EAST MAIN PUYALLUP
 WAREHOUSE- RED DOT TI

Description: No: Date:
 PERMIT SUBMITTAL 05/09/2022

**CONTEXT
 LANDSCAPE PLAN**

L100

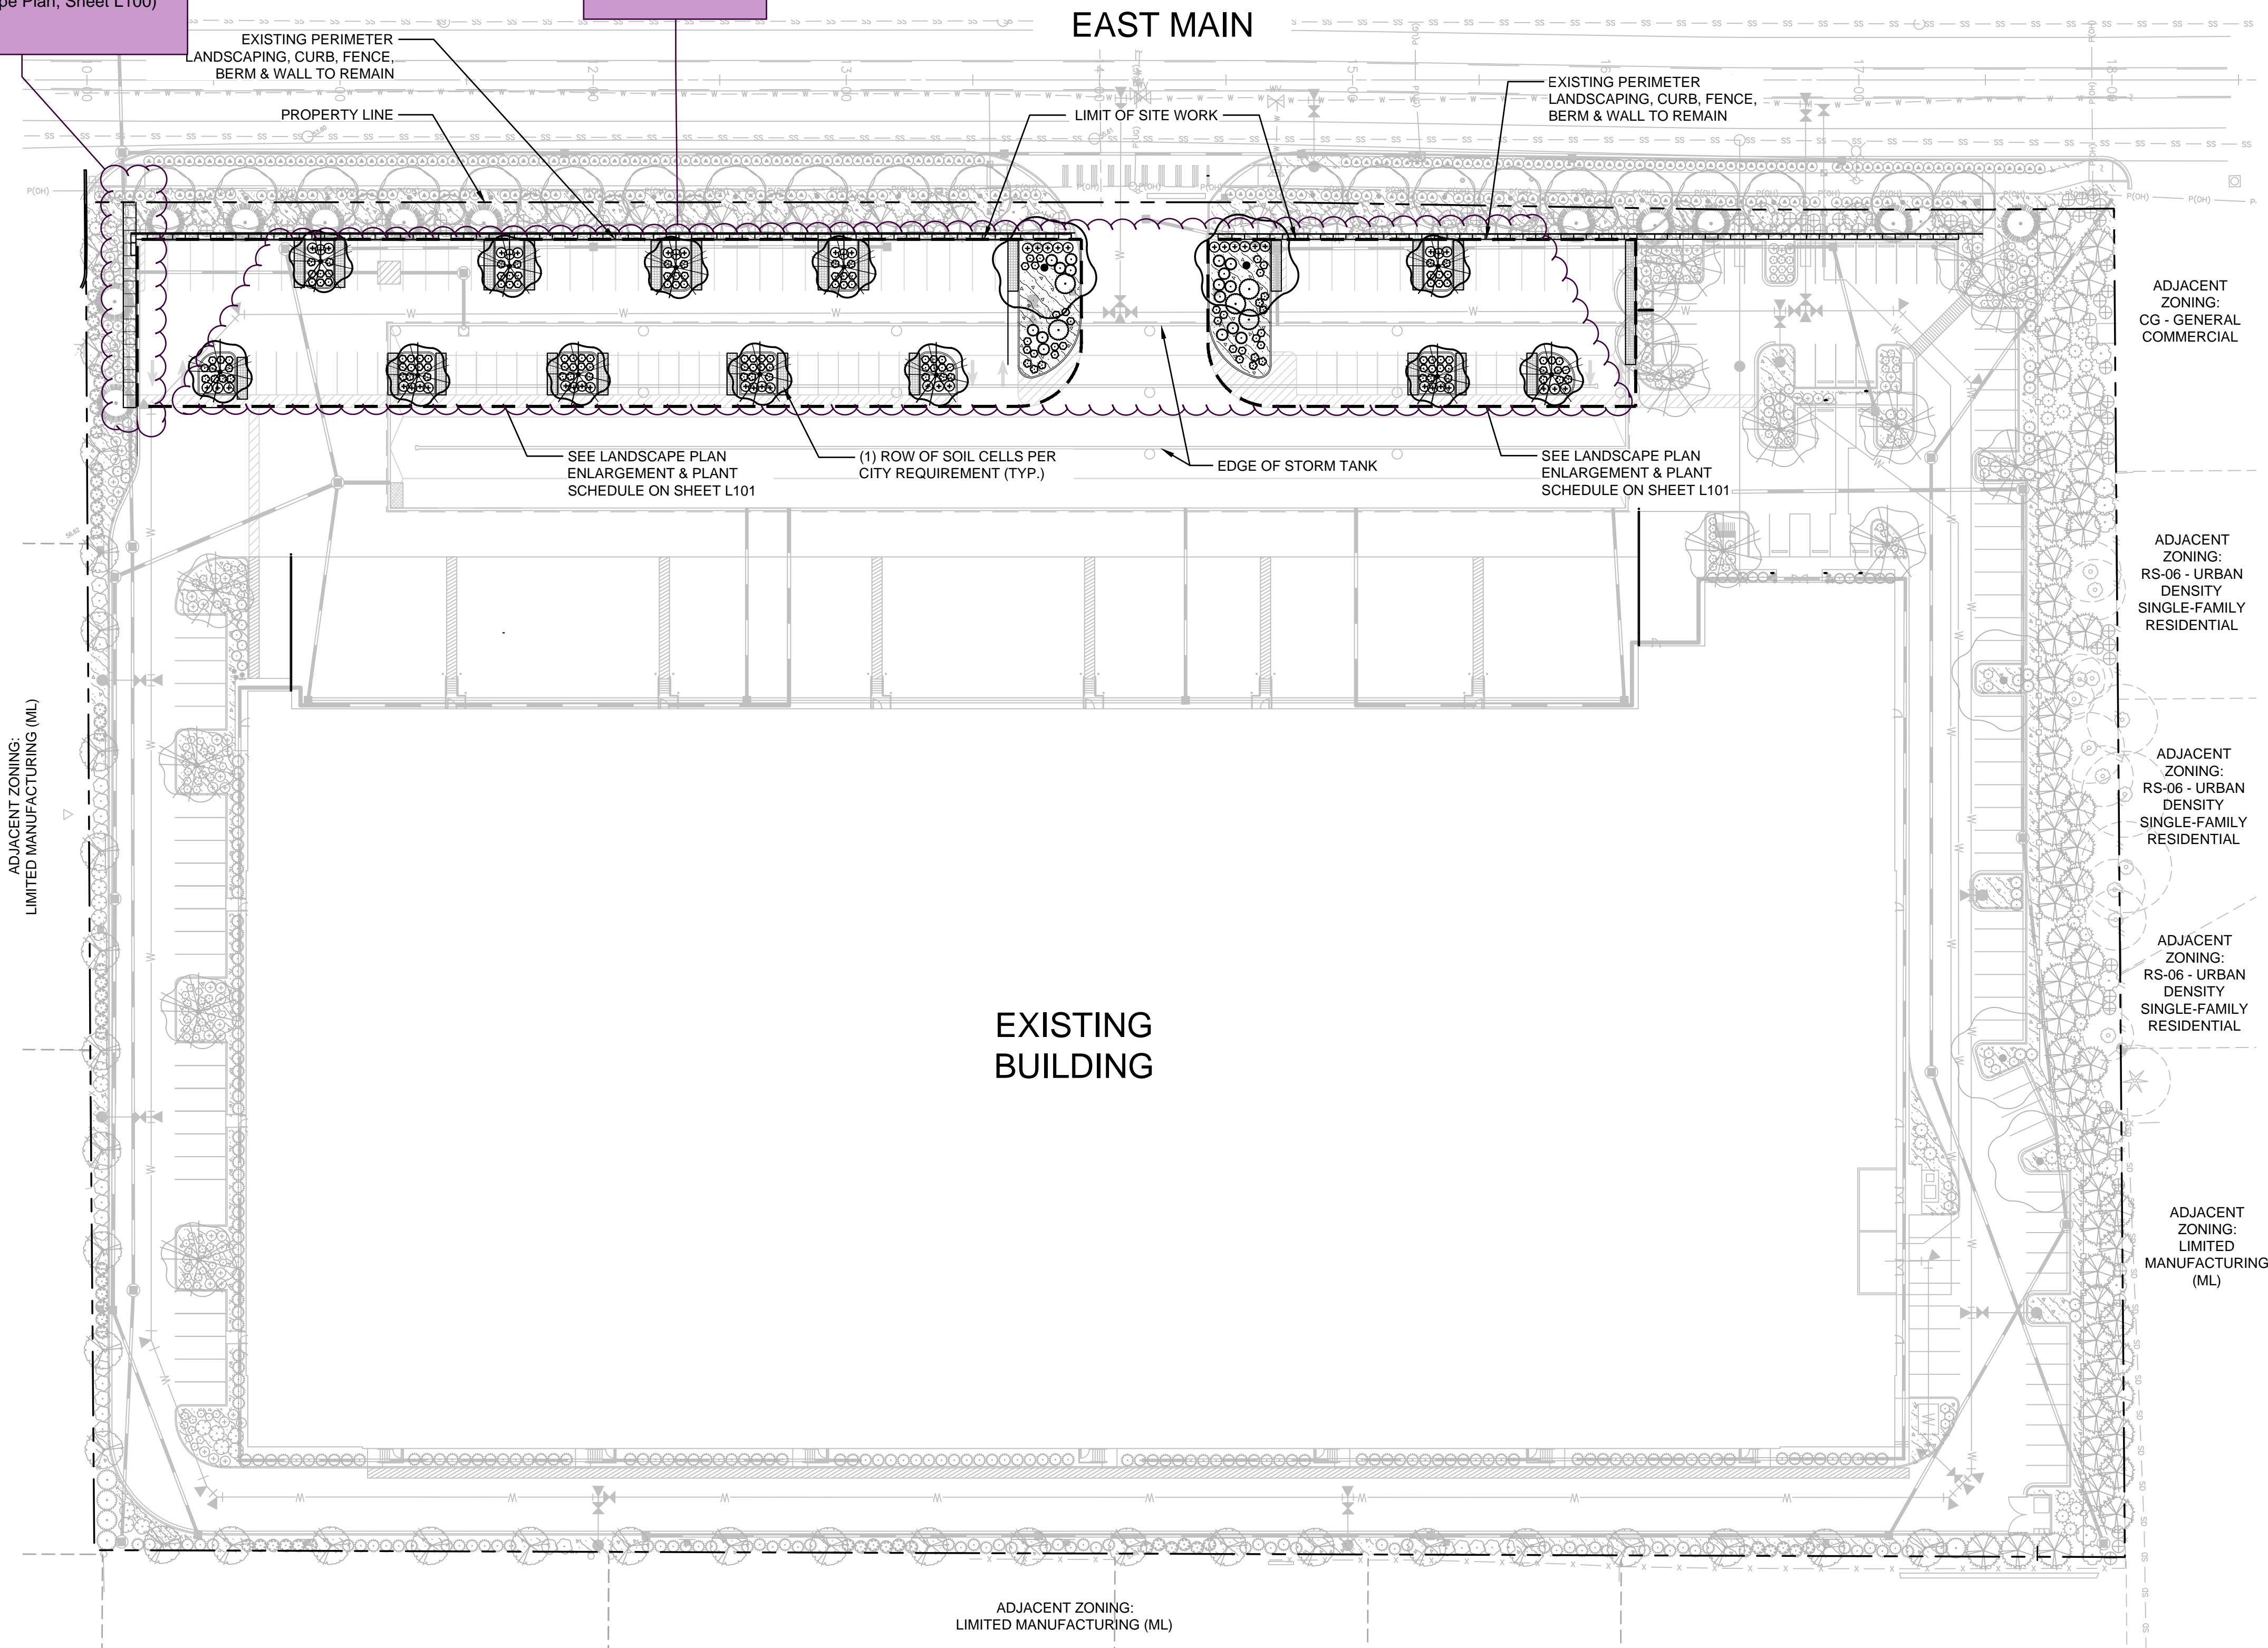
Pedestrian walkway must connect to the sidewalk. It appears that the walkway may have conflicts with the existing retaining wall/fence. As noted on the civil plan set, more information is needed to ensure the walkway does not conflict with the wall and fencing. Landscape plan for this planter needs to be adjusted to show landscaping within the planter with the new walkway (not overlaid). (Landscape Plan, Sheet L100)

Ground cover required within all landscape islands. (Landscape Plan, Sheet L100)

L101

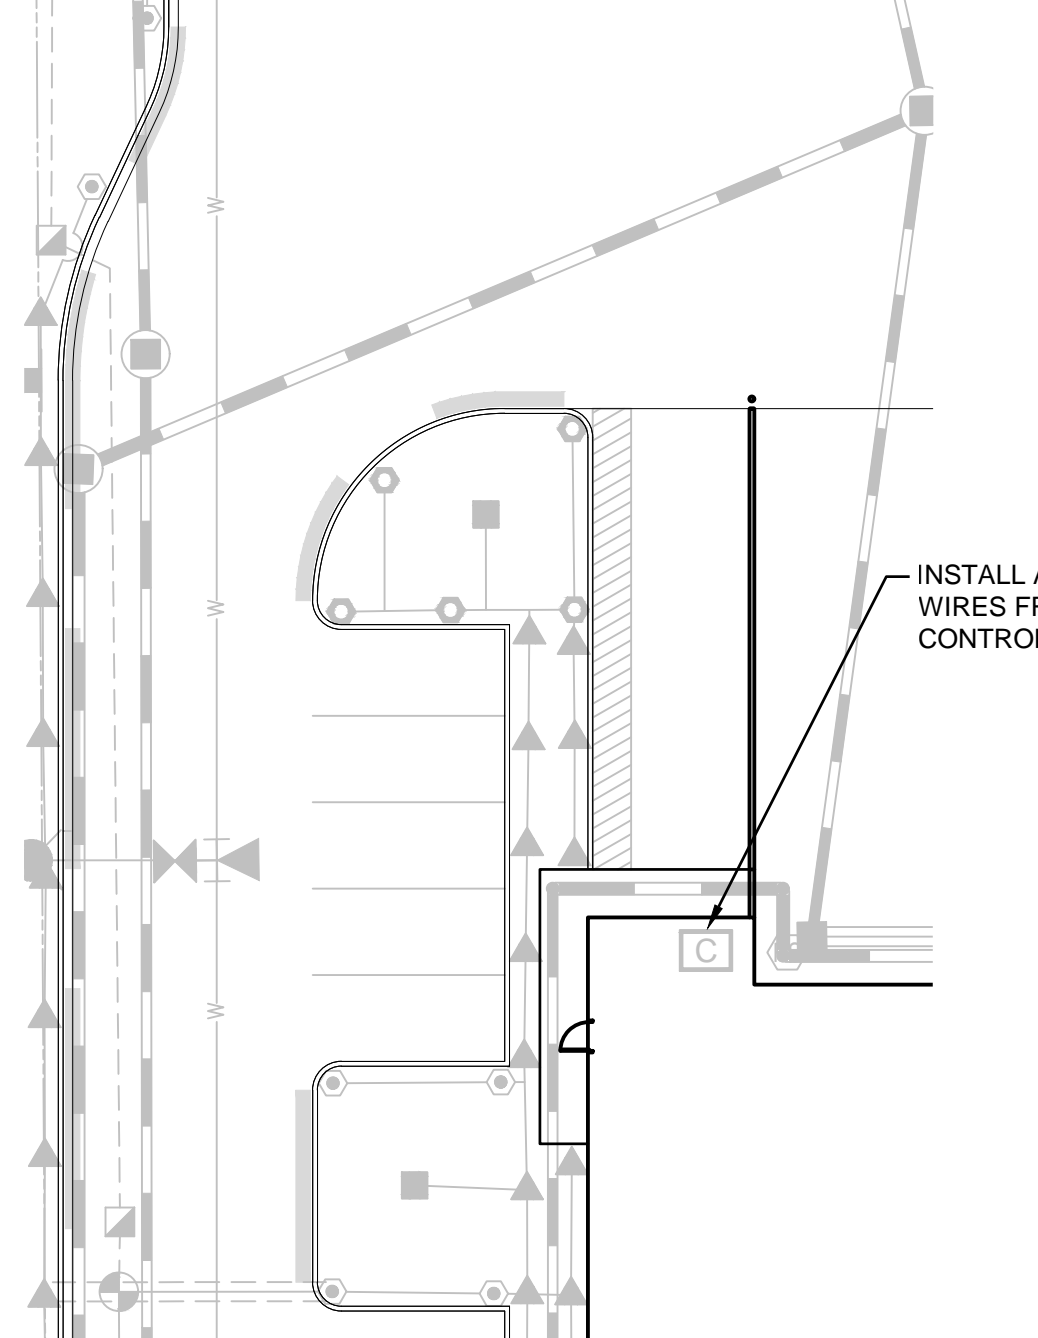
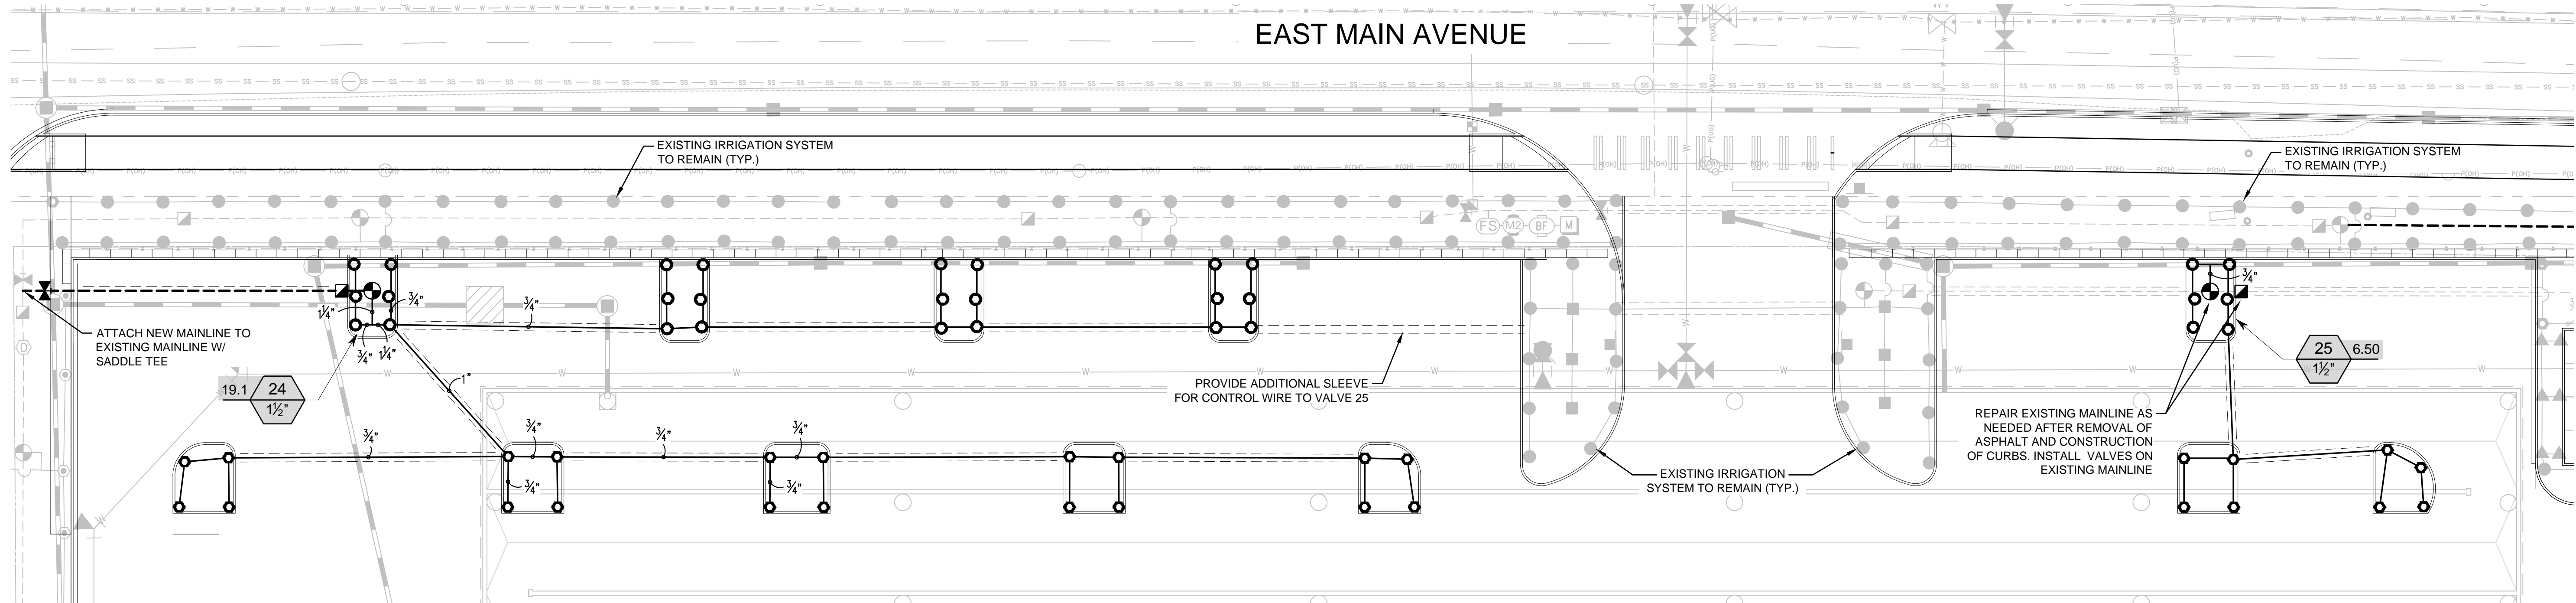
Pedestrian walkway must connect to the sidewalk. It appears that the walkway may have conflicts with the existing retaining wall/fence. As noted on the civil plan set, more information is needed to ensure the walkway does not conflict with the wall and fencing. Landscape plan for this planter needs to be adjusted to show landscaping within the planter with the new walkway (not overlaid). (Landscape Plan, Sheet L101)
